Our ref: 5676

Information request response (pursuant to Schedule 2, Part 2, Section 1 (6) of the Abbot Point SDA Development Scheme (November 2014))

Your Ref: AP2025/009

We refer to the information request, dated 14 October 2025, for the SDA application for material change of use for a utility installation (water pipeline and pump station) in the Abbot Point State Development Area (SDA).

PIPELINE IN ROAD RESERVE/ WITHIN PROPERTY BOUNDARIES TRENCH
TYPICAL INSTALLATION DETAIL
NOT TO SCALE

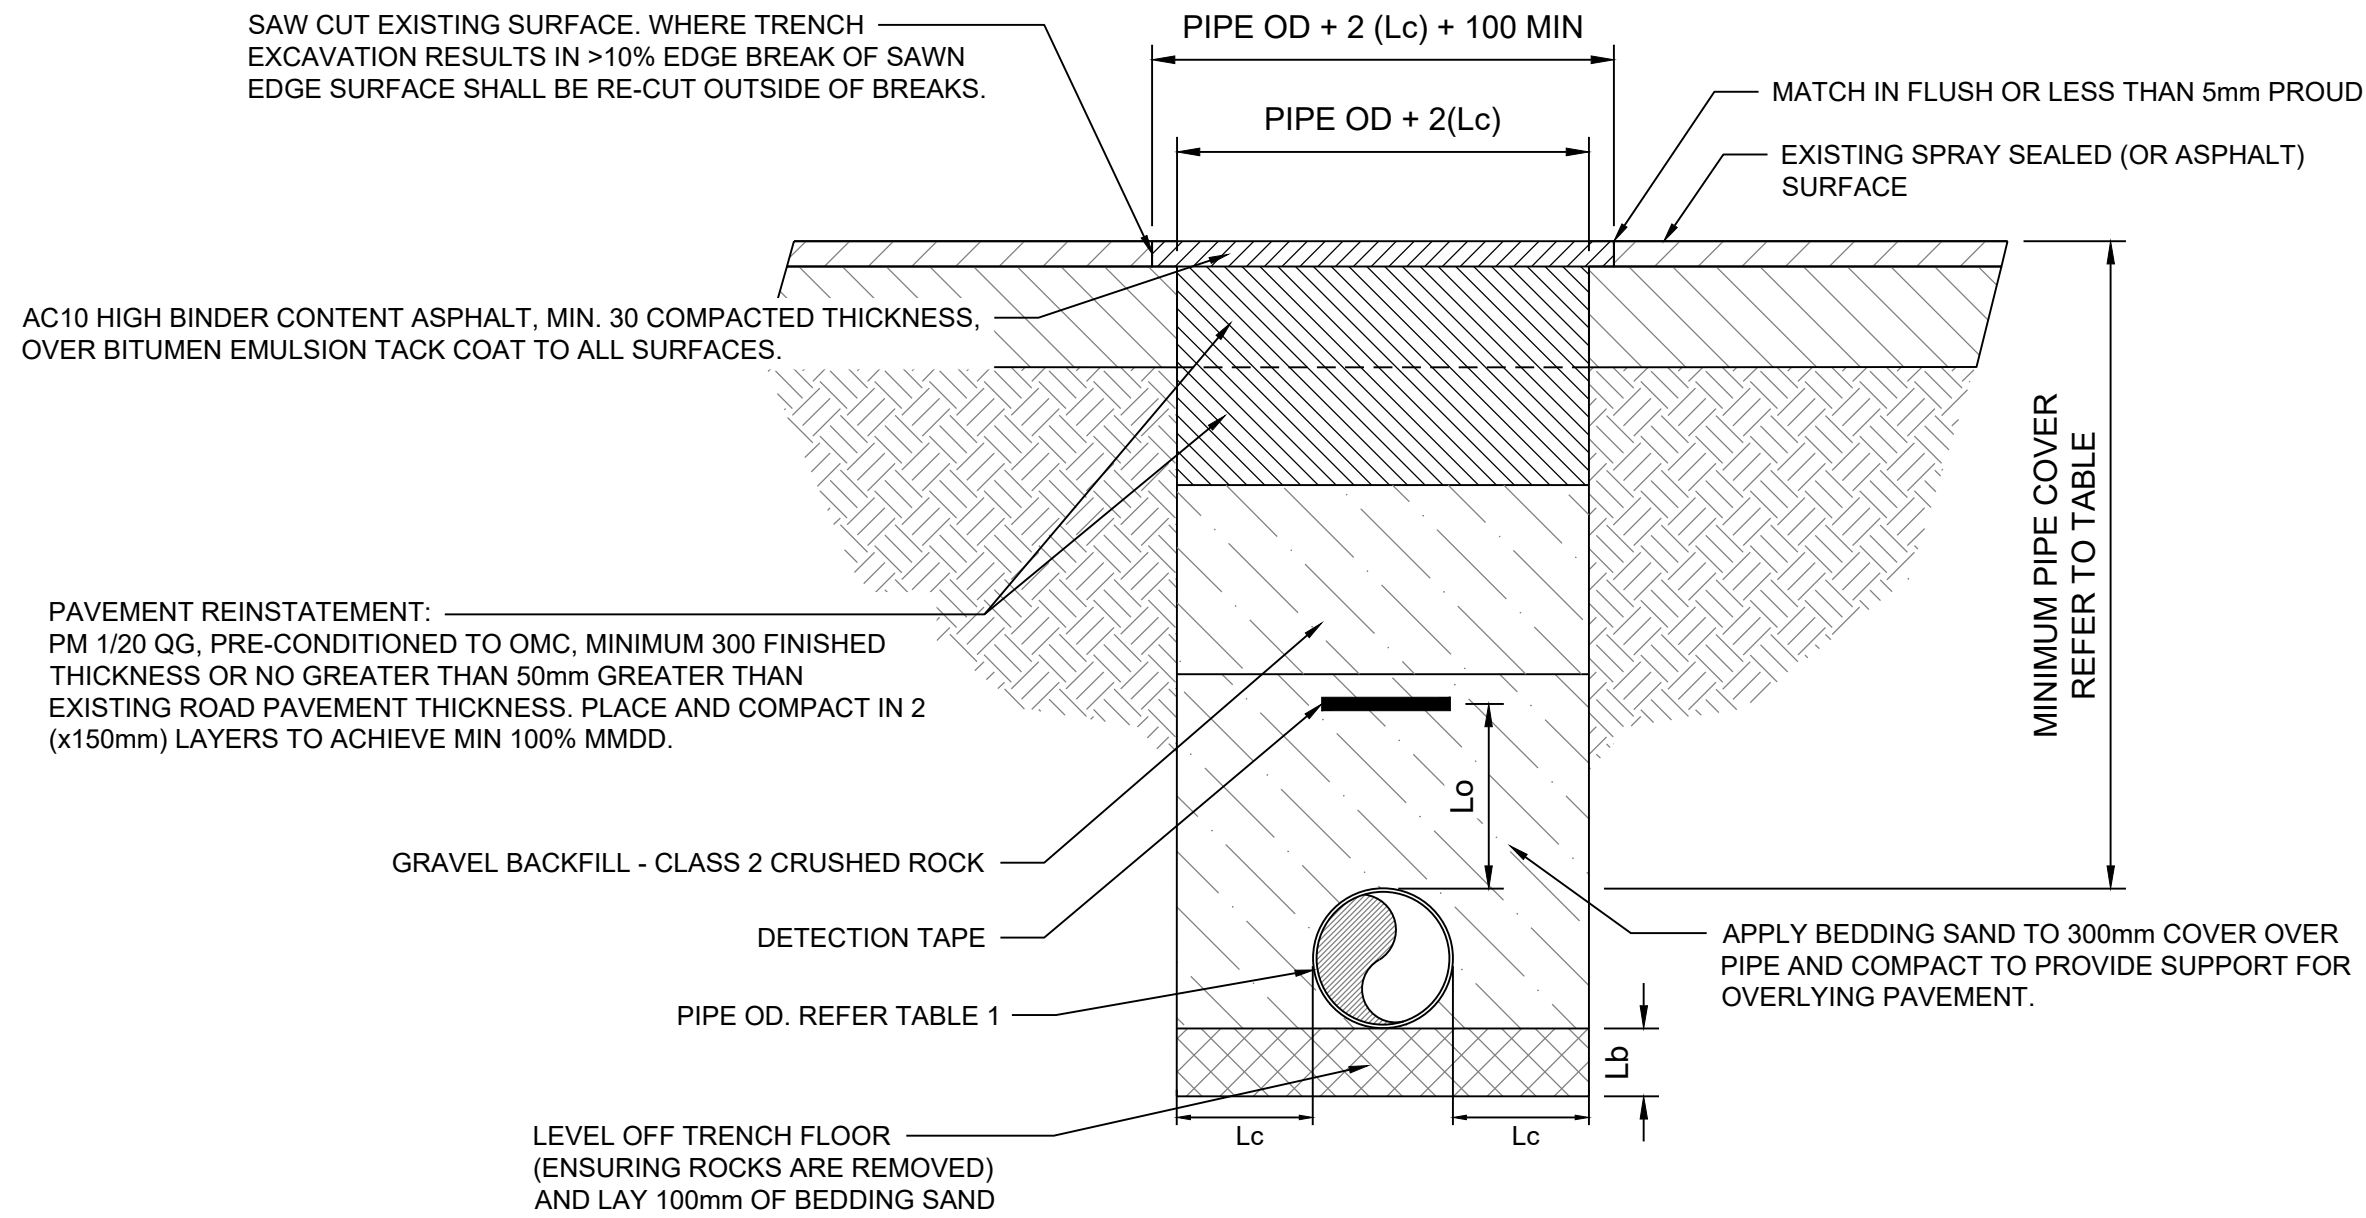
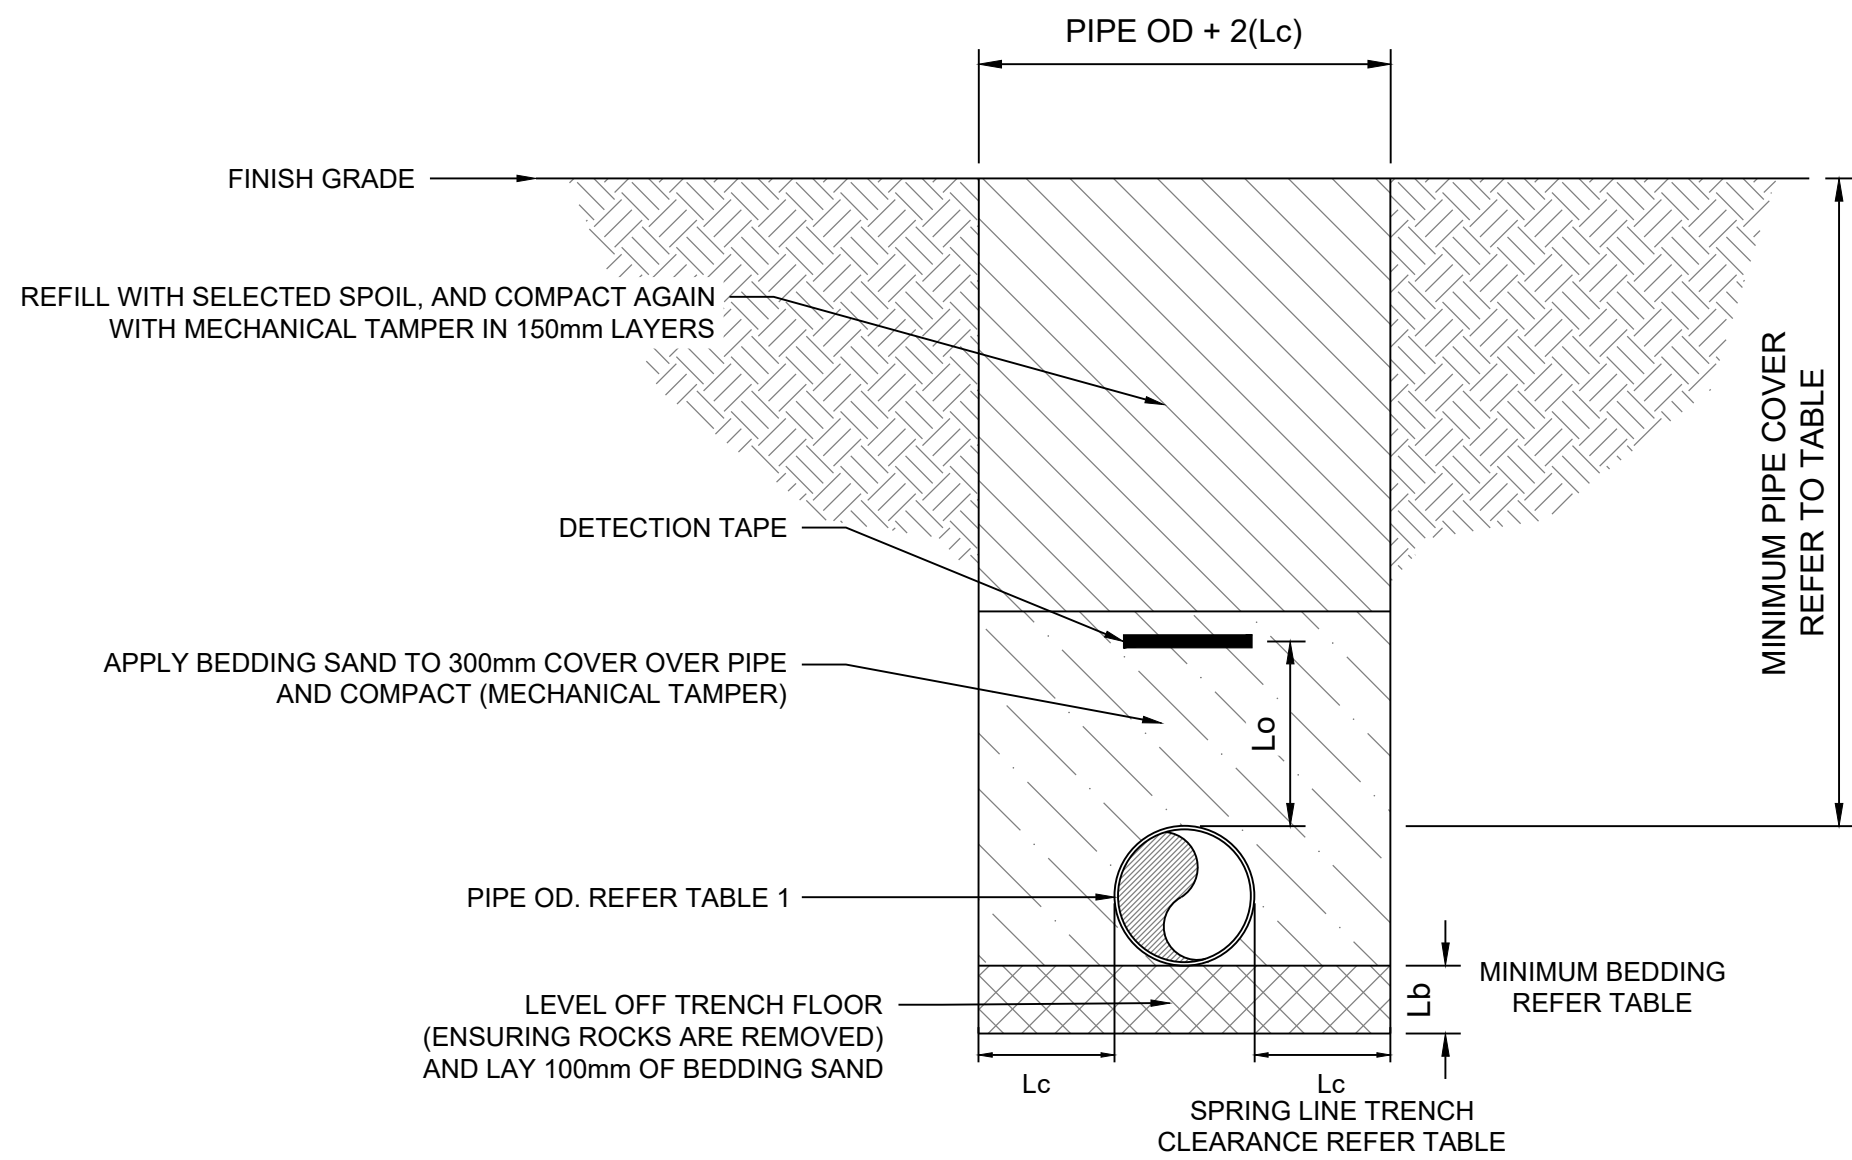
1. Clearly identify the types of operational works seeking to be specified as “SDA self-assessable” i.e. civil works, clearing native vegetation etc

2. Clearly outline the extent of the operational works within the SDA that are being sought to be specified as “SDA self-assessable”.

Attachment A contains typical sections of trenching and trenchless installation. It is noted that these sections are preliminary only and not for construction. It is proposed that detailed design drawings of proposed operational works can be submitted to the Office of the Coordinator-General as a condition of approval.

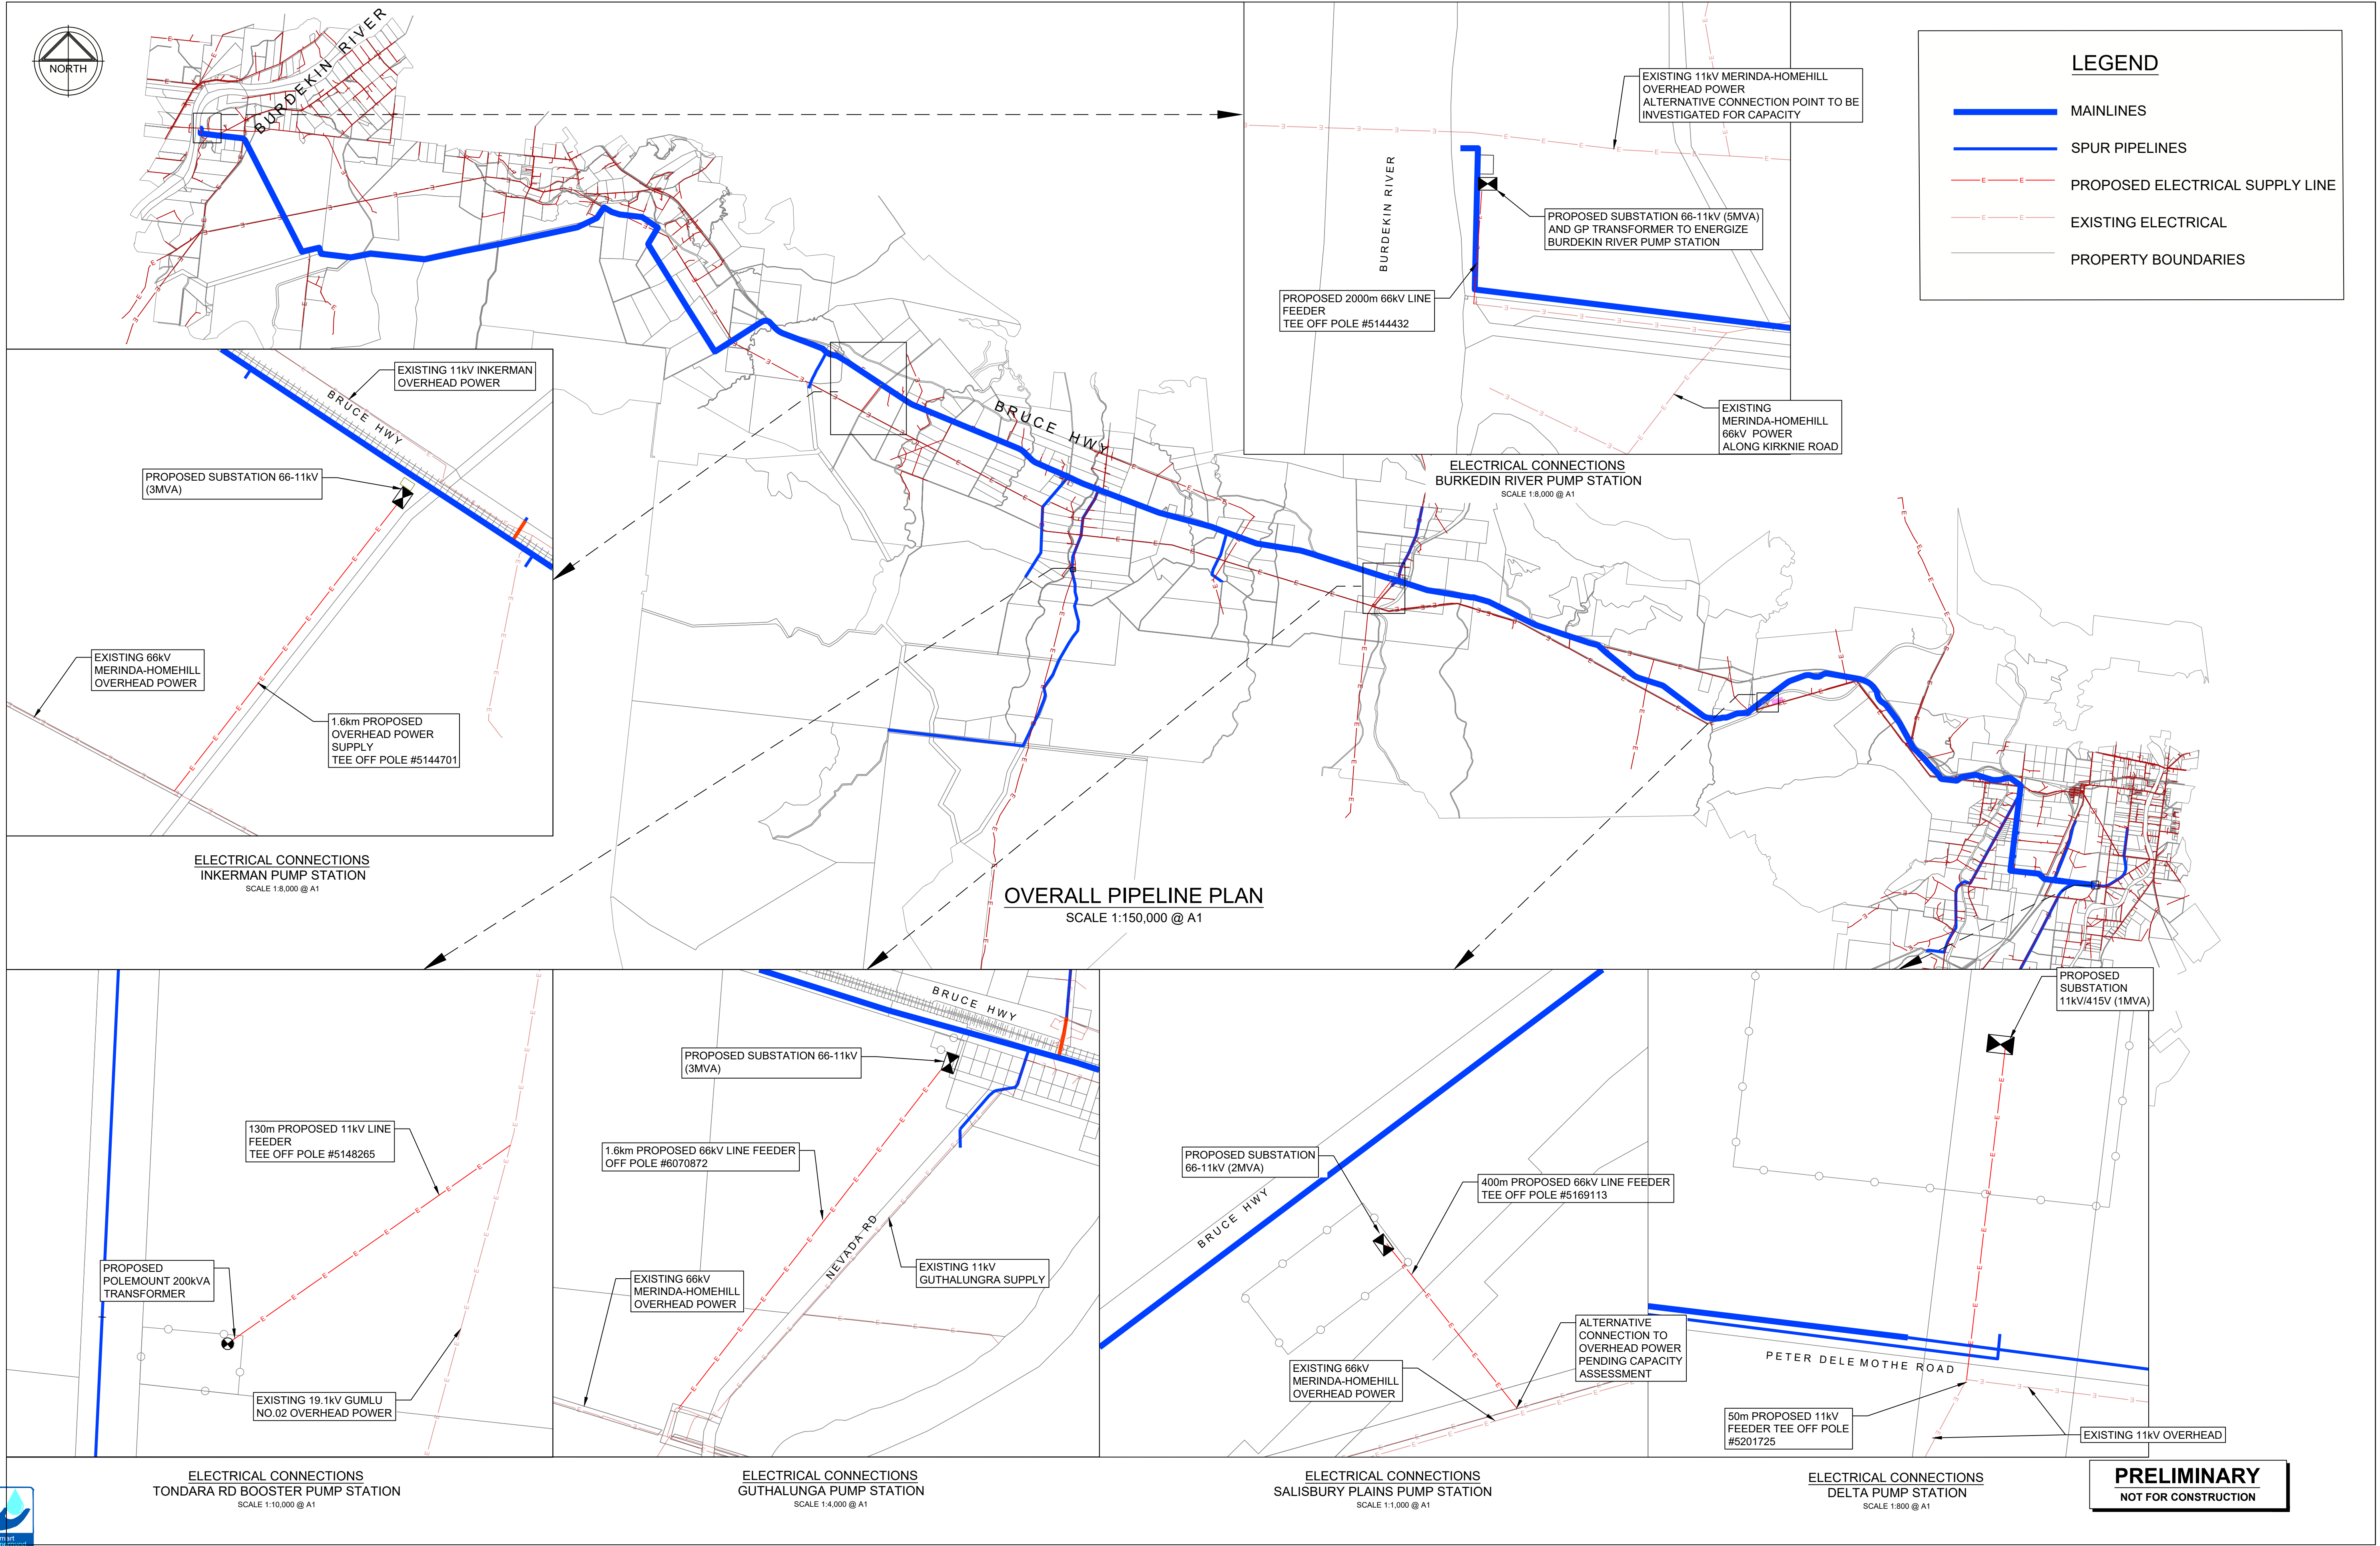
1. Provide a separate site layout plan of the Salisbury Plains Pump Station & Balance tank location referred to in Figure 3 of the Planning Report and a separate plan showing the proposed height and visual appearance referred to in Figure 4 of the Planning Report.
2. Provide plans clearly showing the proposed location of electrical transmission infrastructure within the SDA.

Attachment B contains preliminary plans which show the indicative layout of the proposed pump station, including proposed electrical connection. The ultimate layout and built form would be subject to detailed design. It is expected that subject to detailed design, key details of the pump station would be as follows:
